APPEAL SUMMARY

Appeal ID: 20217	Project Address: 1620 SW TAYLOR
Hearing Date: 4/10/19	Appellant Name: ERIC HOFFMAN
Case No.: B-015	Appellant Phone: 503-715-5847
Appeal Type: Building	Plans Examiner/Inspector: JEFF DONNELLY
Project Type: commercial	Stories: 3 Occupancy: B Construction Type: IIIB
Building/Business Name: HARSCH MANAGEMENT OFFICES	Fire Sprinklers: Yes - CEILING
Appeal Involves: Alteration of an existing structure	LUR or Permit Application No.: 2019-114560-000-00-FA
Plan Submitted Option: pdf [File 1] [File 2]	Proposed use: OFFICE

Single exit tenant improvement with reduction in occupant load based on non-simultaneous use: Hold for additional information.

HARSCH MANAGEMENT OFFICES

01. EGRESS PLAN

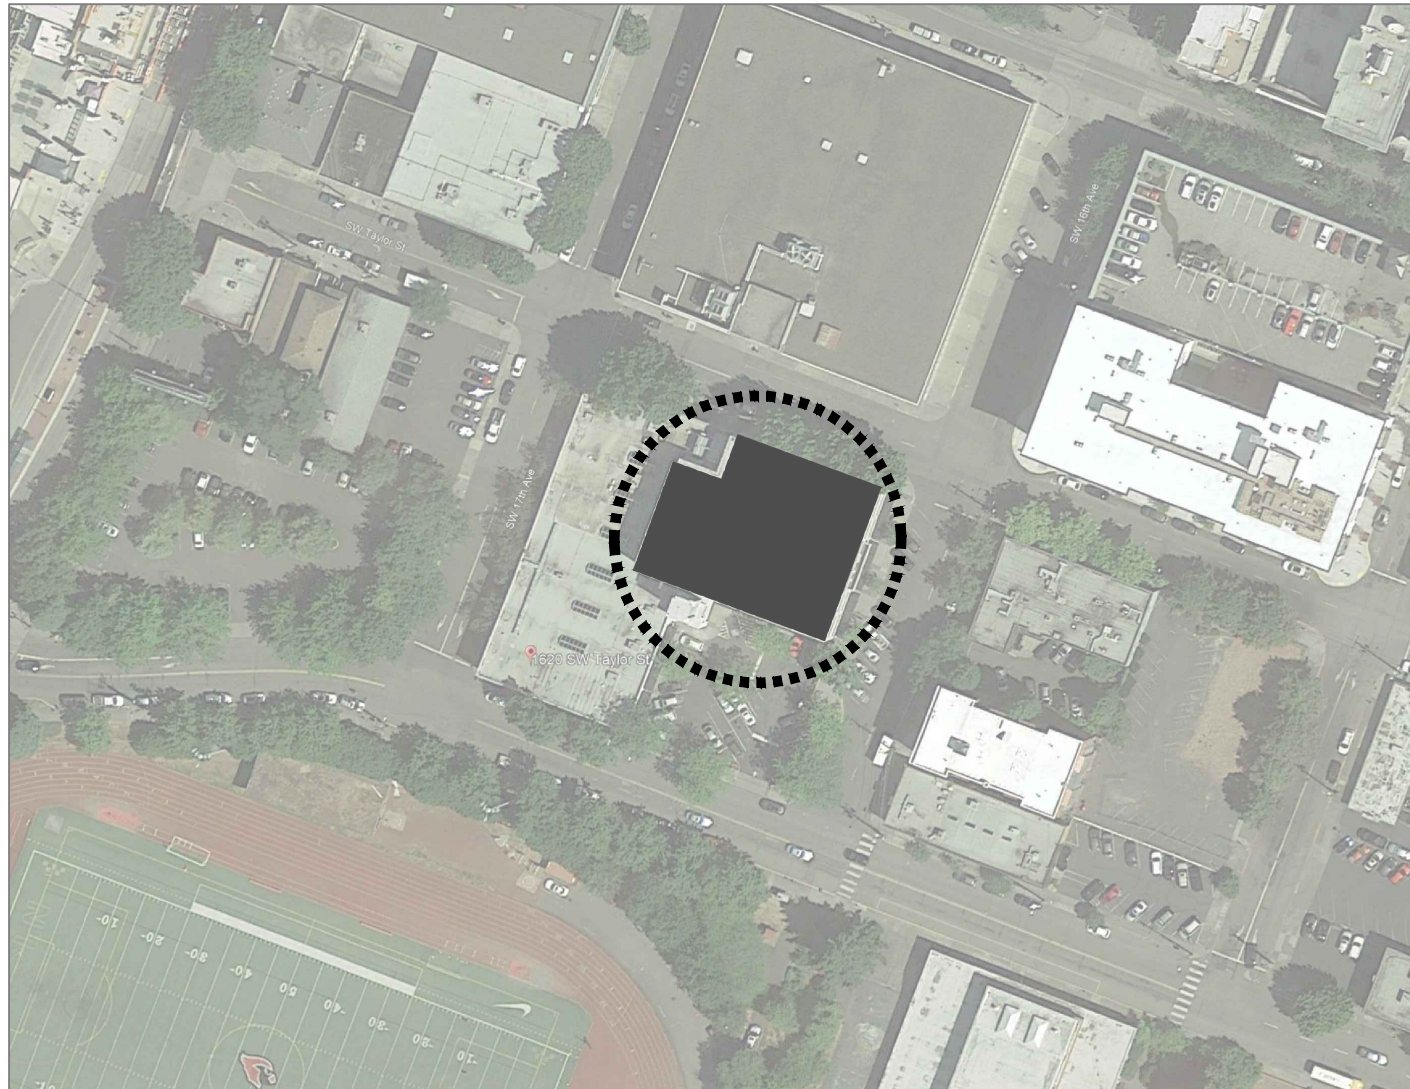
Proposed Design BREAK-ROOM AREA – THE AREA IS A KITCHEN/BREAK ROOM FOR EMPLOYEES TO EAT MEALS BROUGHT TO WORK. THE SPACE WILL NOT AT ANY POINT BE USED FOR MEETINGS OR ASSEMBLY PURPOSES.

THE AREA OF THE SPACE IS 419 SF. PER TABLE 1004.1.2, THE SPACE WOULD BE CLASSIFIED AS AN ASSEMBLY OCCUPANCY WITH 15 NET SQUARE FEET PER OCCUPANT.

419 SF / 15 NSF = 28 OCCUPANTS.

HOWEVER, DUE TO THE ACTUAL FUNCTION OF THE AREA, WE ARE PROPOSING THAT THE BREAK ROOM BE CONSIDERED A NON-SIMULTANEOUS USE OF THE PRIMARY B OCCUPANCY. AT NO POINT ARE NEW OCCUPANTS BEING ADDED TO THE OVERALL

TENANT SPACE DUE TO THE BREAK ROOM – BUT RATHER THE OCCUPANT LOAD SHIFTS FROM ONE AREA TO ANOTHER AT LUNCH AND BREAK TIMES.

THIS PROPOSAL WILL SEEK TO LIMIT THE DESIGN OCCUPANT LOAD TO 4 OCCUPANTS FOR THIS SPACE.

Reason for alternative SINCE THE BREAK ROOM WILL BE USED NON-SIMULTANEOUSLY BY THE SAME OCCUPANTS AS THE MAIN OFFICE AREAS, THE OCCUPANT LOAD SHOULD BE APPROPRIATELY CALCULATED THE SAME AS THE LOAD OF THE OFFICE AREAS WITHOUT INCLUDING THE OCCUPANT LOAD INCREASE OF AN ASSEMBLY AREA. THIS RESULTS IN A TOTAL OCCUPANT LOAD OF 48 FOR THE ENTIRE TENANT SPACE. PER TABLE 1015.1, ONE EXIT ACCESS DOORWAY IS SUFFICIENT.
